Great Wilsey Park, Haverhill

Designers Response to Road Safety Audits for Access Strategy off Chalkstone Way

20th April 2017

**Road Safety Audit
Stage 1**

Figure 2a: Alternative Chalkstone Way Access

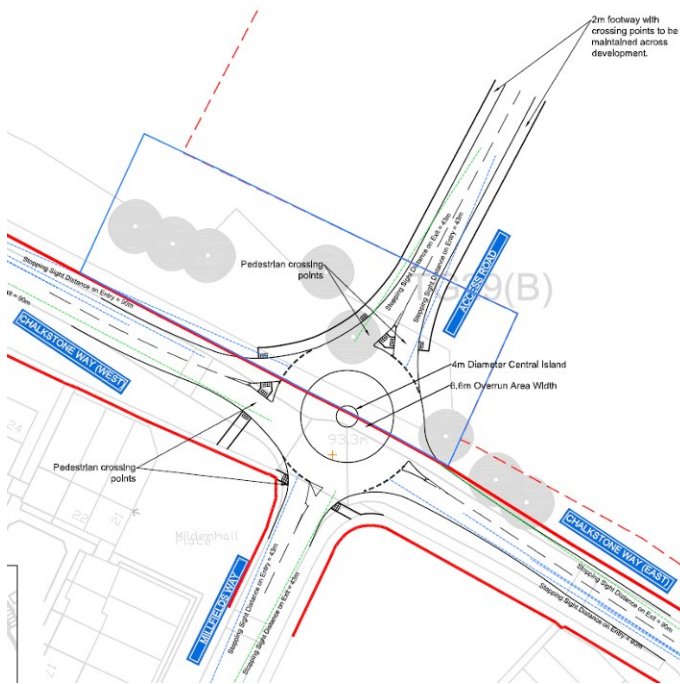
Problem 1: Inadequate deflection on vehicle paths

For the roundabout entry from the east (Chalkstone Way) the entry path curvature is in the region of 140m and for the roundabout entry from the north the entry path curvature is in the region of 100m, both using the over-run area edge as the vehicle path guide. Such potential approach paths give inadequate entry path curvature to fully-prevent traffic from entering the roundabout at too high a speed or having to resort to late-braking (DMRB standard TD16 also refers).

The drawings do not show any traffic calming measures on the development Access Road. Whilst the Auditors do acknowledge that Chalkstone Way is a traffic-calmed road the situation could be hazardous to cyclists, particularly in view of the wide overall circulatory carriageway width as associated with all compact roundabout layouts that are designed to accommodate specific large/long vehicle types, not all of which type might use the subject roundabout and approach roads.

- The roundabout should be re-designed to ensure that vehicle entry paths have radii tighter than 70m radius (such re-design might involve the provision of a larger roundabout); and
- Traffic calming should be applied to the development Access Road.

Problem 2: NMUs

The footway from the development ends at the north-western quadrant with pedestrians having to cross Chalkstone Way to gain access to the existing footway along the southern side of Chalkstone Way. Not far west of the proposed roundabout is the Westfield Primary Academy school so the Auditors would expect some NMU demand between the development (the Access Road roundabout) and the school which is not catered for in the current proposals unless such trips cross and re-cross Chalkstone Way.

The recommendation is that the footway along the western side of the development Access Road should be continued on to the school entrance not far west of the proposed roundabout with, perhaps, enhancement to shared cyclist/pedestrian status.

Problem 3: Bus stop location

The existing bus stop west of the roundabout is located only approx. 25m ahead of the roundabout 'Give Way' line and the drawing has no indications of bus stop relocation.

The recommendation is that the bus stop should be relocated further west, sufficiently away from the roundabout.

Problem 4: Speed cushion feature

There is an existing speed cushion arrangement immediately west of the roundabout located only approx. 15m ahead of the roundabout 'Give Way' line and the drawing has no indications of its removal. With a roundabout so close the speed cushion

The recommendation is that the speed cushion arrangement should be relocated a short distance further west.

Designer's Response: *The Auditors comment about the deflection has been duly noted but is to be challenged. Using TD16 Guidance, the Designer cannot achieve the Auditors quoted under-provision for deflection.*

However, and in positive response, the roundabout approach arms have been verified as compliant with TD16 and have received minor realignment to achieve the optimal deflection.

The matter of traffic calming measures for the development access road is duly noted. However, this is a matter of detail and as such will be addressed at the Reserved Matters stage and subject to the Stage 2 Road Safety Audit.

***Designer's Response:** The existing footways which run to the south of Chalkstone Way are 2m which is adequate width for pedestrians, they have been considered and incorporated into the design. All internal NMU routes are incorporated within the parameters plan and road hierarchy, which will be developed in detail as part of the detailed application. The footways shown replicate the existing footway alongside Chalkstone Way. Due to design constraints posed by third party land ownership issues, it is not viable to continue the footway west along the north side of Chalkstone Way to the proposed development.*

***BCL Response:** It is difficult to deduce from either DMRB, Manual for Streets or Local Transport Notes where a bus stop should be positioned in relationship to a roundabout. However, it is known from TD 16/07 that a pedestrian crossing should not be positioned between 20m or 60m on entry to a roundabout. Given that a stationary bus would encourage a motorist to stop just like a pedestrian crossing would, the same principle shall be applied here. Therefore, the bus stop is advised to be relocated to be 60m west of the roundabout.*

Designer’s Response: It is difficult to deduce from either DMRB, Manual for Streets or Local Transport Notes where a speed cushion should be positioned in relationship to a roundabout. However, it is known from TD 16/07 that a pedestrian crossing should not be positioned between 20m or 60m on entry to a roundabout. Given that a speed cushion would encourage a motorist to slow down just like a pedestrian crossing would, the same principle shall be applied here. Therefore, the speed cushion is advised to be relocated to be 20m west of the roundabout.

FIGURE 462/3/4

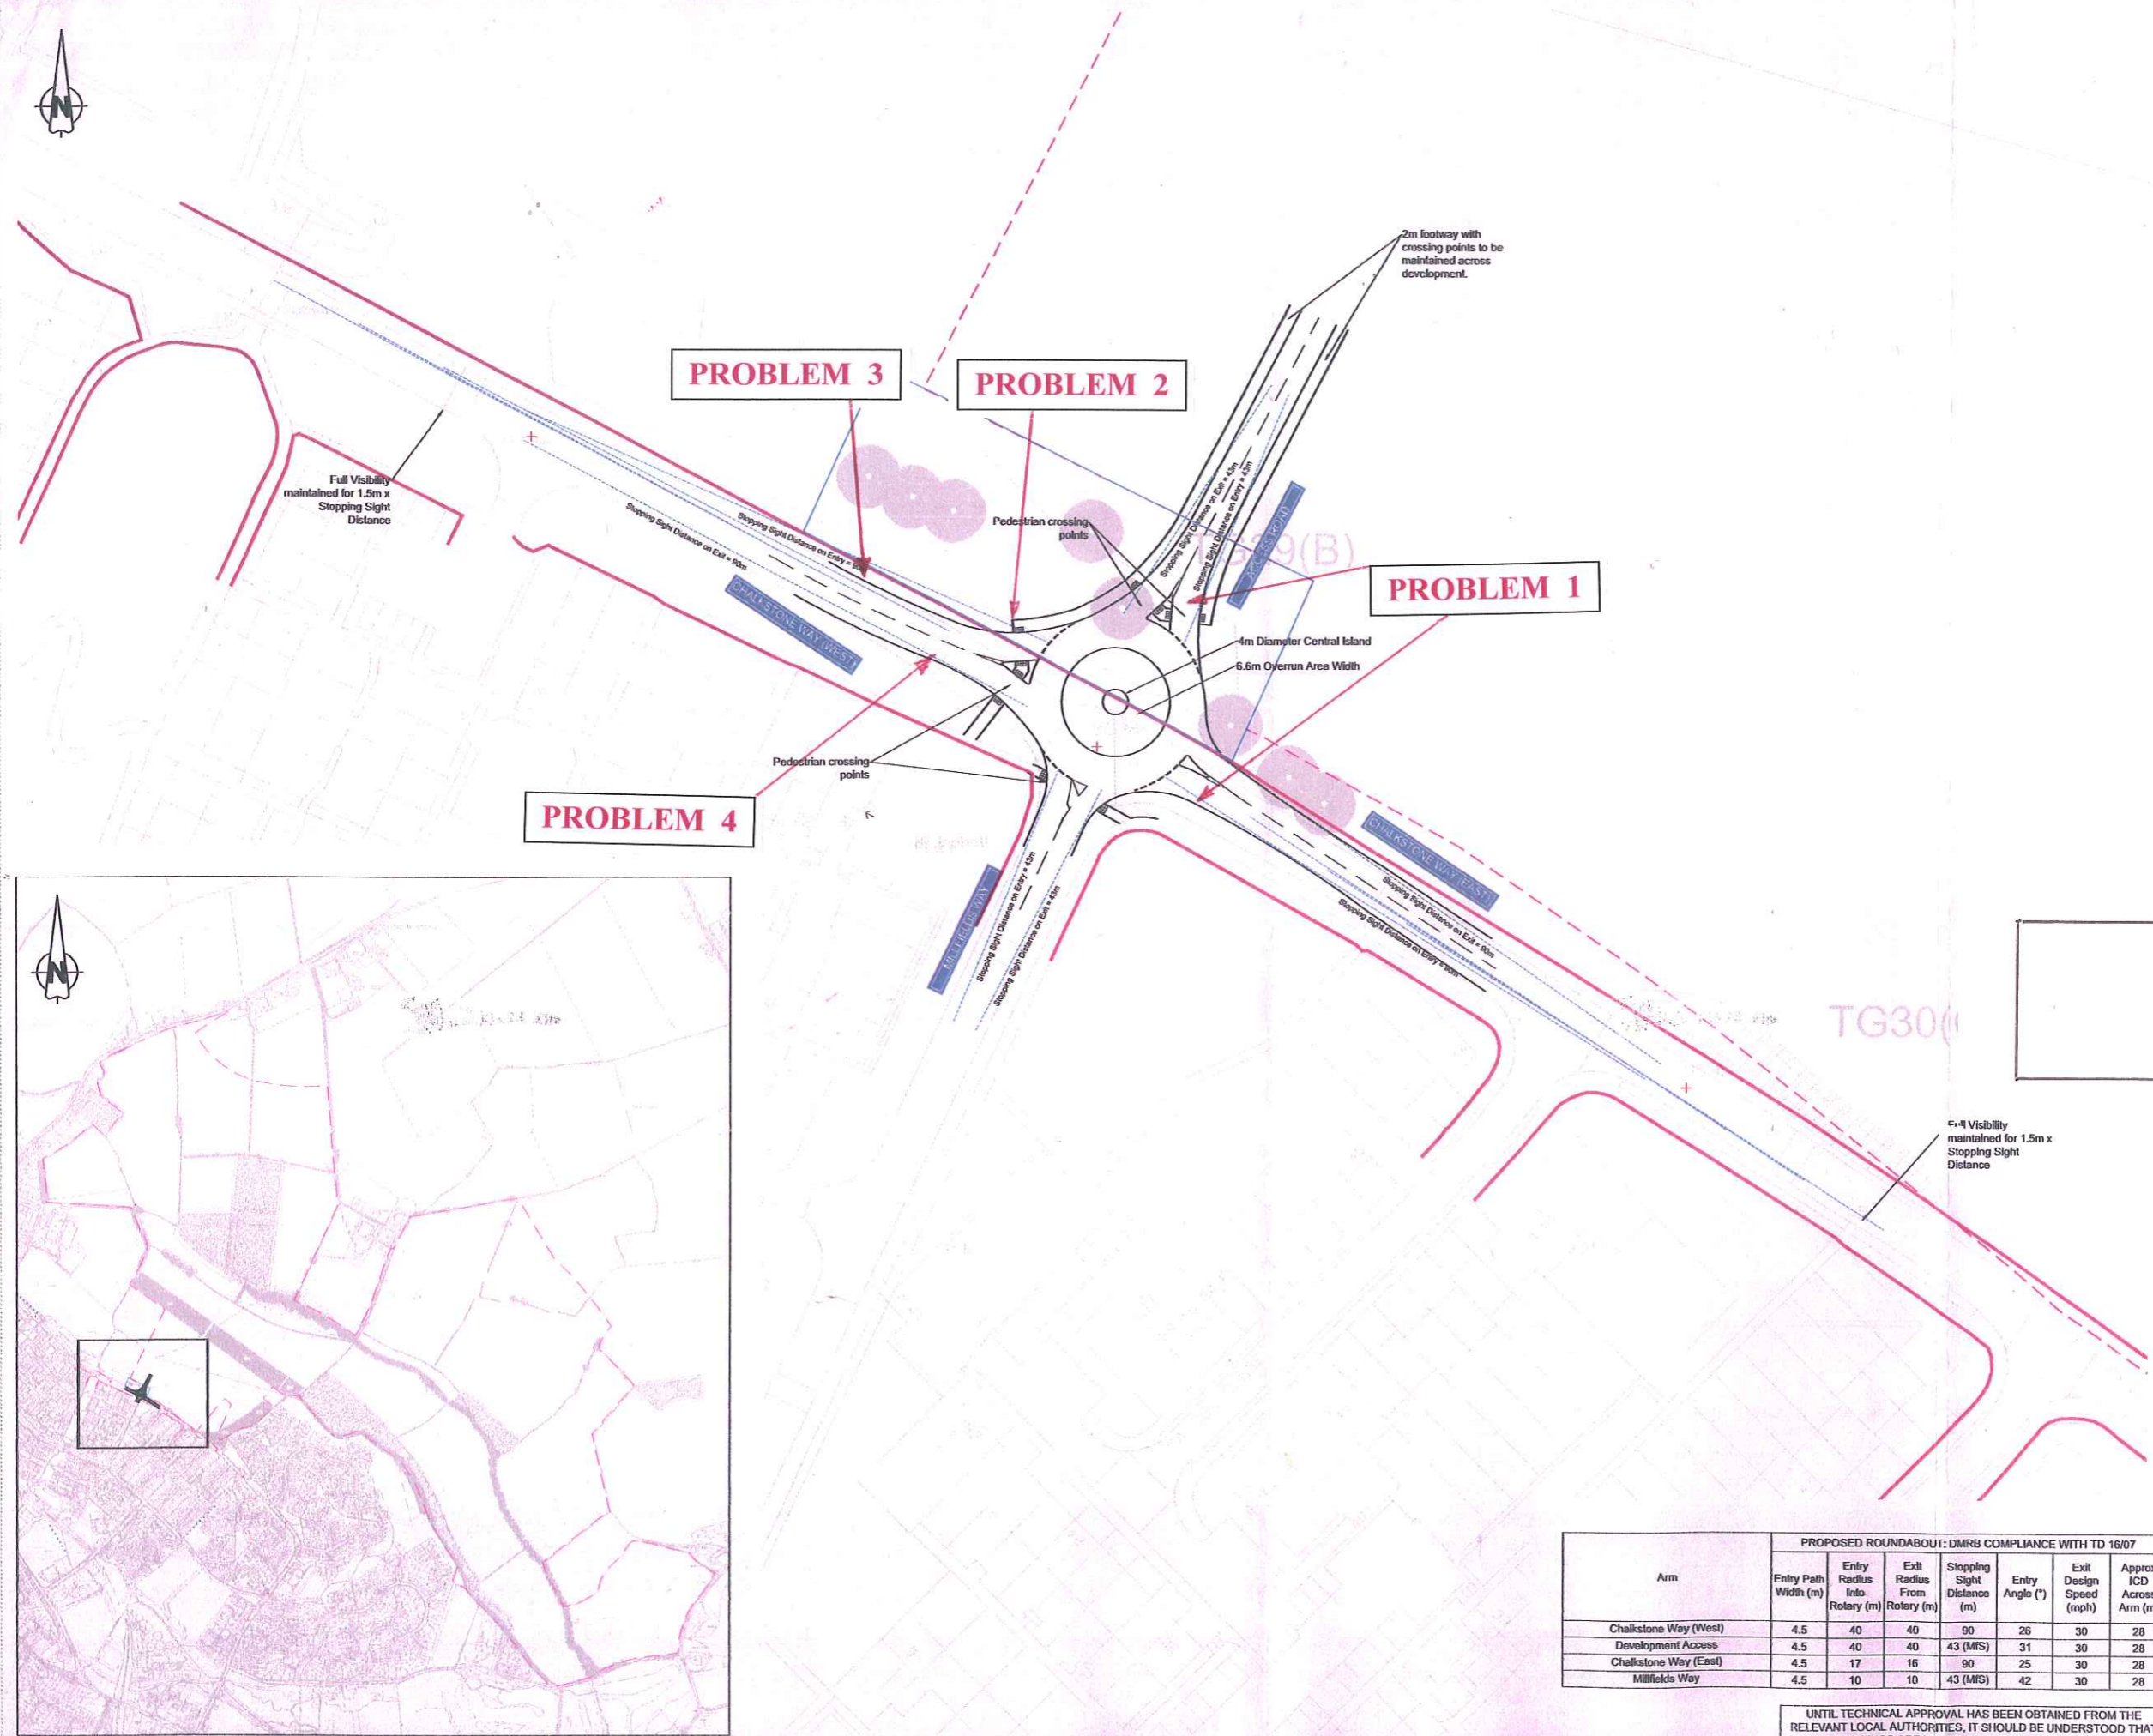
3.1 **Problem 1 : Inadequate deflection on vehicle paths**

3.1.1 For the roundabout entry from the east (Chalkstone Way) the entry path curvature is in the region of 140m and for the roundabout entry from the north the entry path curvature is in the region of 100m, both using the over-run area edge as the vehicle path guide. Such potential approach paths give inadequate entry path curvature to fully-prevent traffic from entering the roundabout at too high a speed or having to resort to late-braking (DMRB standard TD16 also refers).

3.1.2 The drawings do not show any traffic calming measures on the development Access Road.

3.1.3 Whilst the Auditors do acknowledge that Chalkstone Way is a traffic-calmed road the situation could be hazardous to cyclists, particularly in view of the wide overall circulatory carriageway width as associated with all compact roundabout layouts that are designed to accommodate specific large/long vehicle types, not all of which type might use the subject roundabout and approach roads.

- The roundabout should be re-designed to ensure that vehicle entry paths have radii tighter than 70m radius (such re-design might involve the provision of a larger roundabout) ; and
- Traffic calming should be applied to the development Access Road.

3.2 **Problem 2 : NMUs**

3.2.1 The footway from the development ends at the northwestern quadrant with pedestrians having to cross Chalkstone Way to gain access to the existing footway along the southern side of Chalkstone Way. Not far west of the proposed roundabout is the Westfield Primary Academy school so the Auditors would expect some NMU demand between the development (the Access Road roundabout) and the school which is not catered for in the current proposals unless such trips cross and re-cross Chalkstone Way.

- The footway along the western side of the development Access Road should be continued on to the school entrance not far west of the proposed roundabout with, perhaps, enhancement to shared cyclist/pedestrian status.

3.3 Problem 3 : Bus stop location

3.3.1 The existing bus stop west of the roundabout is located only approx. 25m ahead of the roundabout 'Give Way' line and the drawing has no indications of bus stop relocation.

- The bus stop should be relocated further west, sufficiently away from the roundabout.

3.4 Problem 4 : Speed cushion feature

3.4.1 There is an existing speed cushion arrangement immediately west of the roundabout located only approx. 15m ahead of the roundabout 'Give Way' line and the drawing has no indications of its removal. With a roundabout so close the speed cushion arrangement would appear superfluous and could safely be removed – however, 'Problem 1' relates in respect of speed control on the roundabout approaches.

- The speed cushion arrangement should be relocated a short distance further west.
